Subject: INSTRUMENT PANEL NOISE - DRIVER SIDE	Bulletin No: 09-023/06
	Last Issued: 6/1/2006

2004-2006 RX-8 vehicles with VINs lower than JM1 FE**** ** 201566 (produced before February 2, 2006)

REMOVE COWL GRILL

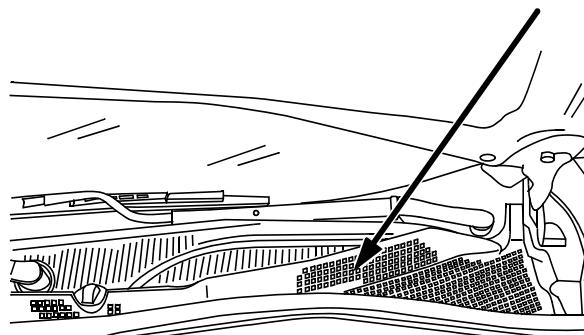
1. Verify customer concern.
2. Remove both front wiper arms. Refer to Workshop Manual section 09-19 WINDSHIELD WIPER ARM AND BLADE REMOVAL / INSTALLATION.
3. Remove the cowl grill. Refer to Workshop Manual section 09-16 COWL GRILLE REMOVAL / INSTALLATION.

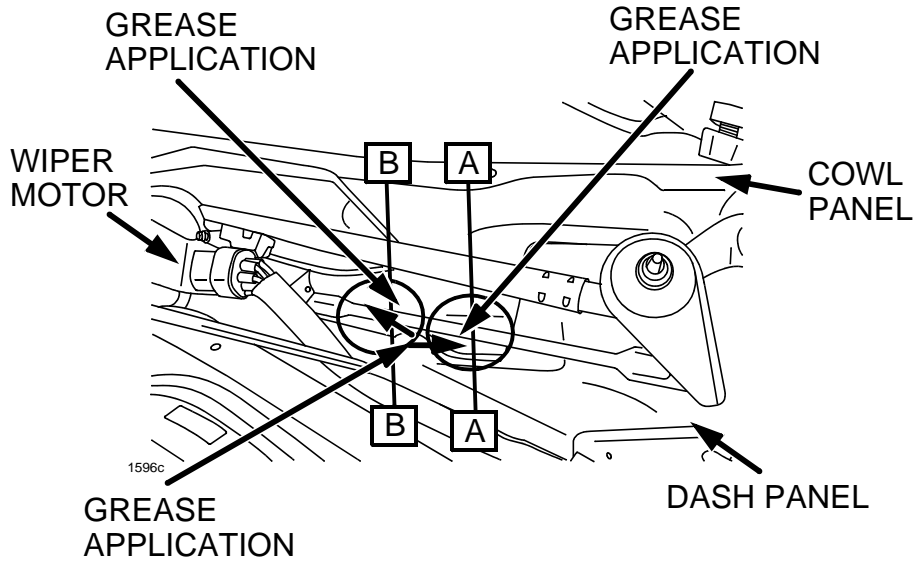
4. Apply waterproof spray grease to mating surfaces between the dash panel and cowl panel as indicated by the circles in the following figure.

- Use locally sourced waterproof spray grease.
